Child cyclist requirement

Minimum forward separation plane distance

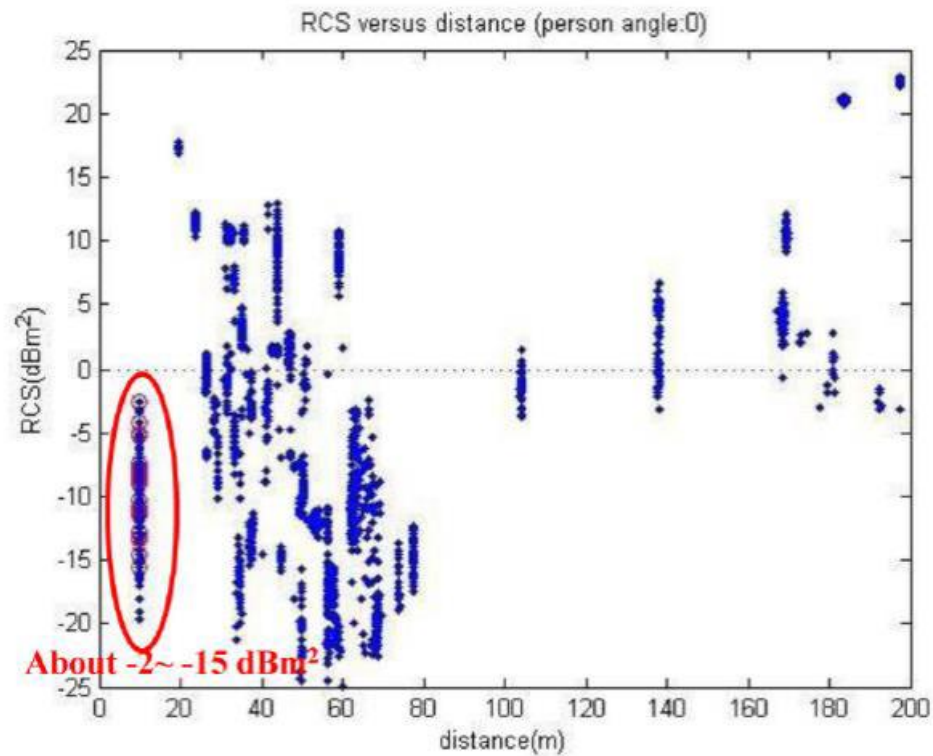
Proposal: 2.29. "Minimum forward separation plane" means the plane perpendicular to the longitudinal plane of the vehicle representing the shortest forward separation distance that the MOIS is required to detect the presence of a VRU. The distance of this plane from the vehicle front shall be ~~0.35m~~ **0.8m**.

- To harmonize the values between vehicle categories, we may propose only one value
 - Minimum requirement for all MOIS vehicle categories
 - Compromise value that will give more flexibility on the sensor height installation according to the vehicle body

CONSTRAINTS 1

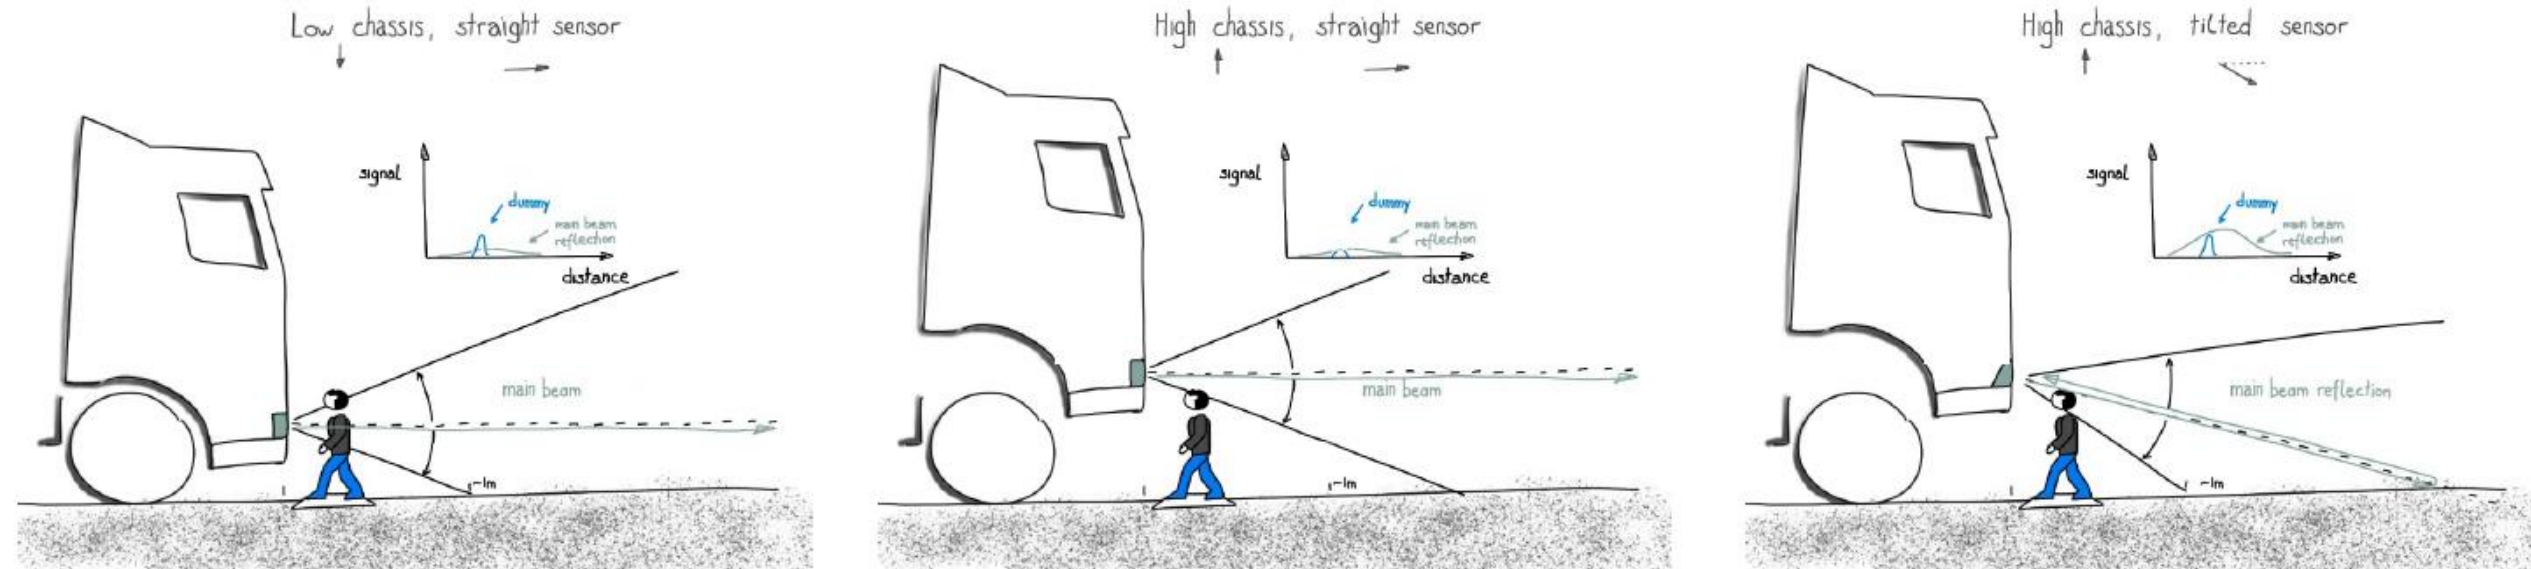
1. Based on theoretical assumptions there are negative implications (reflections, implausible signals,...) with tilted mounting
2. No knowledge on detection performance with tilted mounting under real life conditions (series / series development)

CONSTRAINTS 2

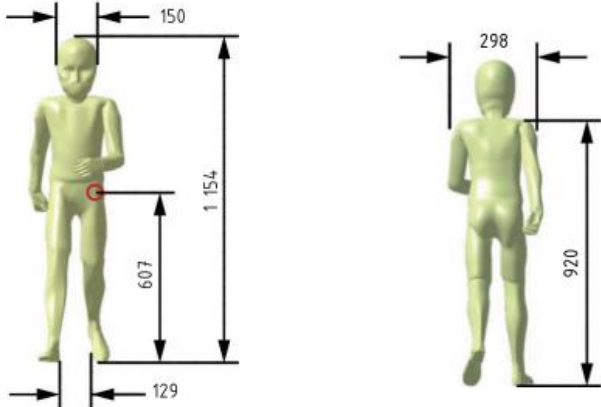
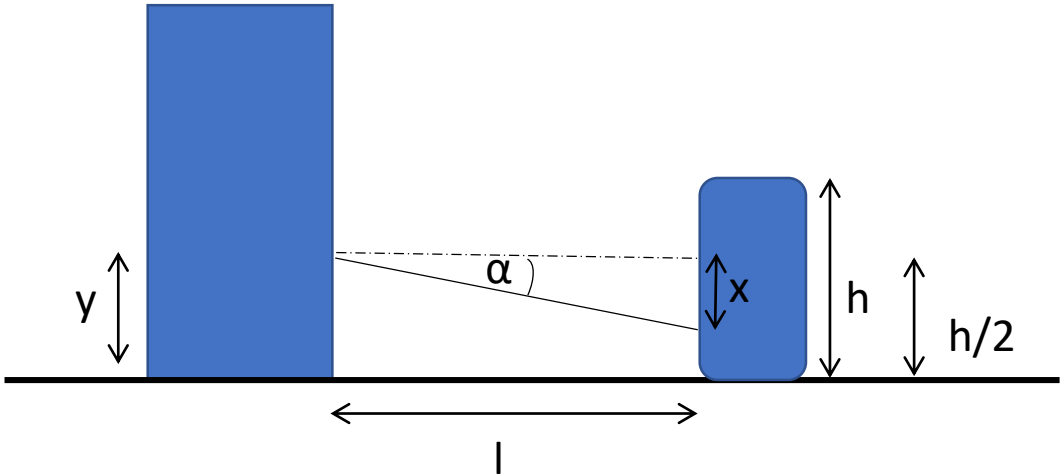
- Vertical opening angle $\alpha \approx \pm 10^\circ$ Elevation
- Distance to dummy $l = 0.35\text{m}$
- Dummy height $h = 1.154\text{m}$
- Body of dummy to cover whole FoV (Elevation)
- RCS value mostly generated by chest of dummy
- Legs of dummy helpful for doppler effect

- Proposed mounting position y for a 0.35 m min forward distance:
0.5-0.75m above ground

6.6. Longitudinal Stopping for Moving Off Cyclist Tests

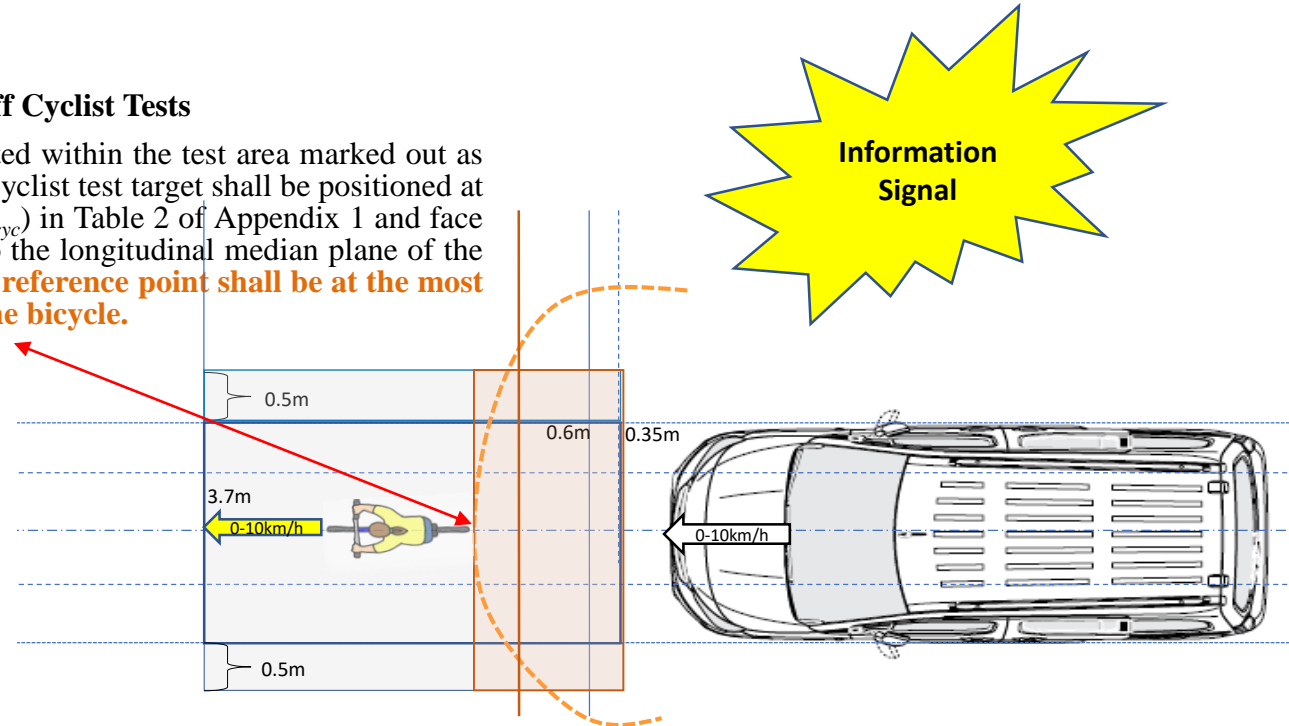
This cyclist is fully visible to the driver (what is the height of a child cyclist target? – supposed >90cm), so that it would be justifiable to set the reference point at where the highest point of the target is (this is presumably somewhere at the CoG of the cyclist) – otherwise we would also contradict to the Blind-Spot principle, in that we are warning/ informing about an object that is visible to the driver.

We have to keep in mind that the purpose of the regulation is to enable detection and recognition, not to automatically prevent a collision.
